Subject: Crystal River Unit 3
Docket No. 50-302
Operating License No. DPR-72

On November 9, 1978 we received your letter of November 2, 1978 requesting that Florida Power Corporation submit additional information concerning our proposed solution to the ECCS small break analysis problem.

Response to Request for Additional Information

ECCS Small Pipe Break Analysis

FIGURE 2

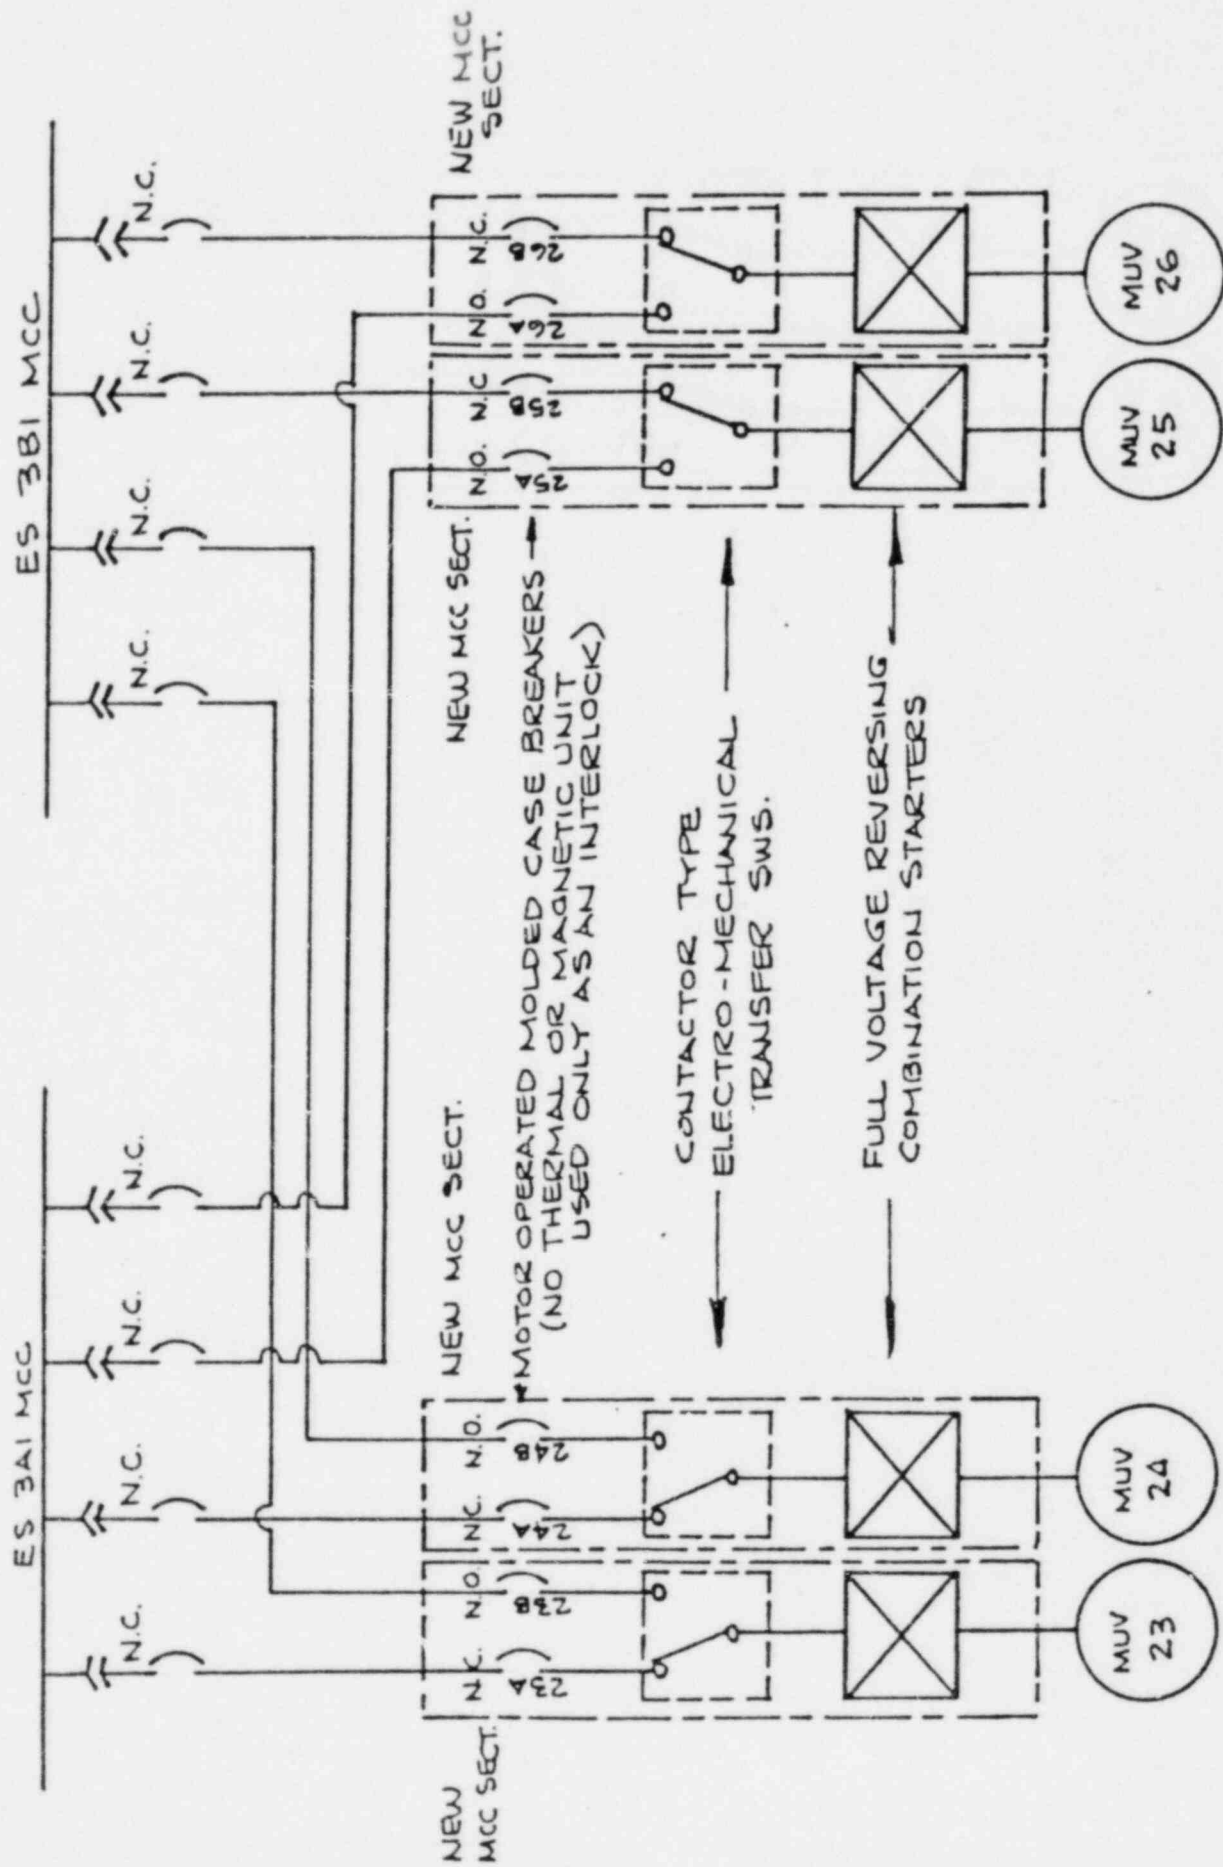
Label Figure 2 to show the normally open (NO) and normally closed (NC) alignment of the breakers in MCC's that supply the MUV's.

Response:

All breakers in MCC ES 3A1 and MCC ES 3B1 are normally closed. The normal status of the breakers in the new MCC sections is shown on Figure 2.

FIGURE 3

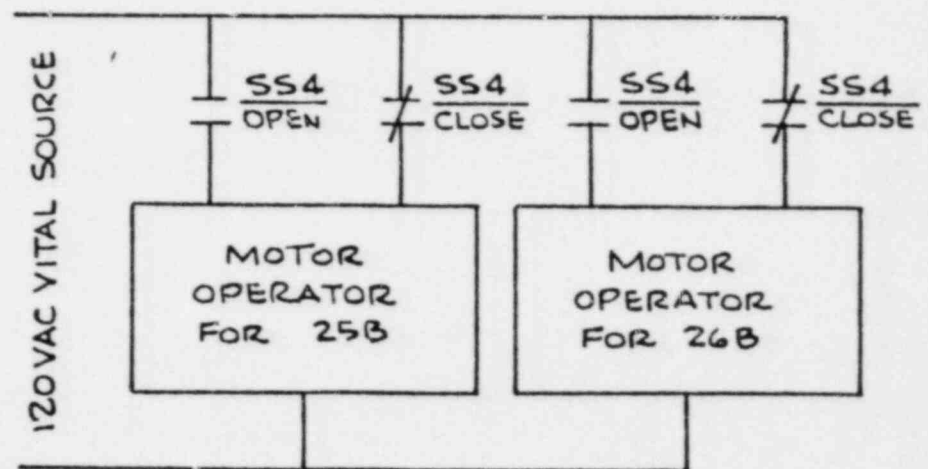
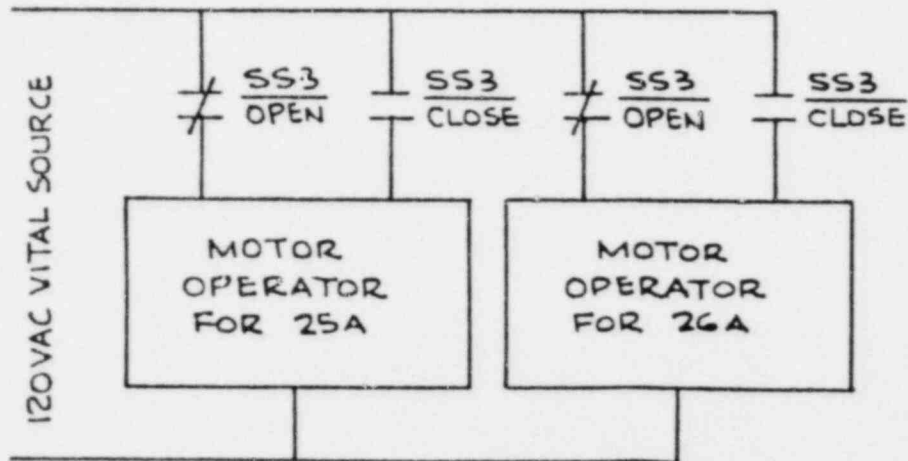
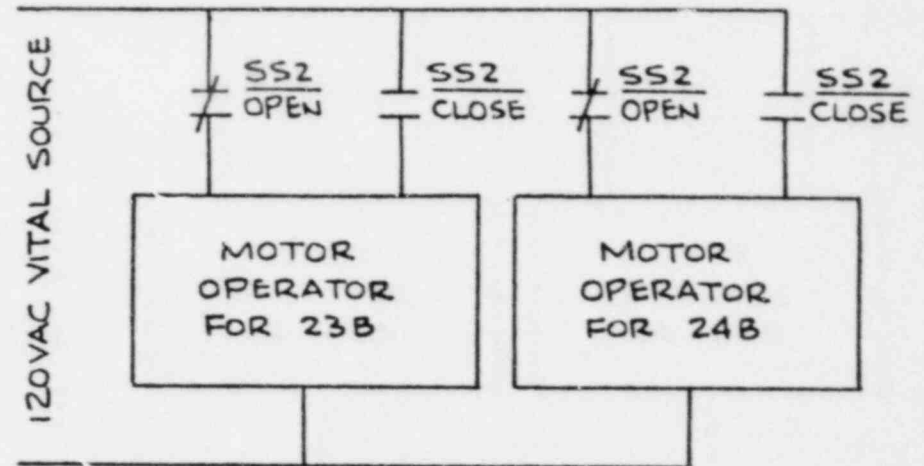
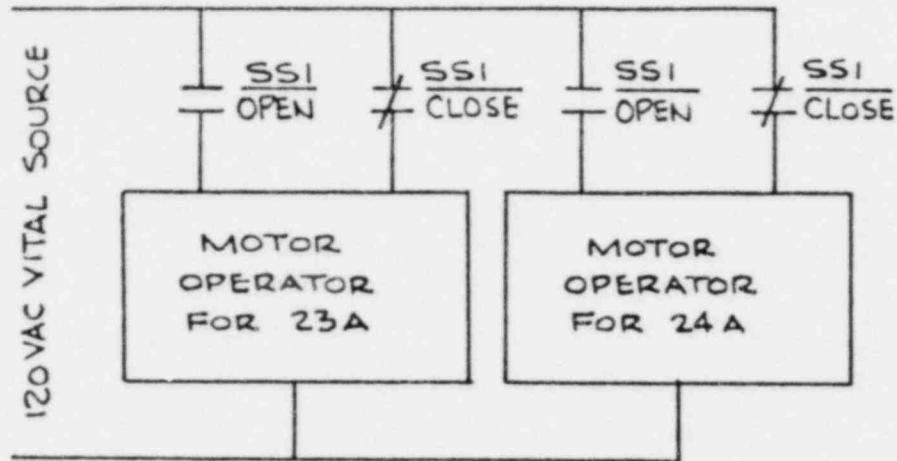
Please provide schematic diagrams showing controls and indications related to motor-operated molded case breakers and electro-mechanical transfer switches.

The schematic diagrams for the motor-operated molded case breakers and electro-mechanical transfer switches are shown on Figures 3 and 4.

Indication will be provided by new selector switches (SS 1, 2, 3, 4) and existing valve position indicating lights.
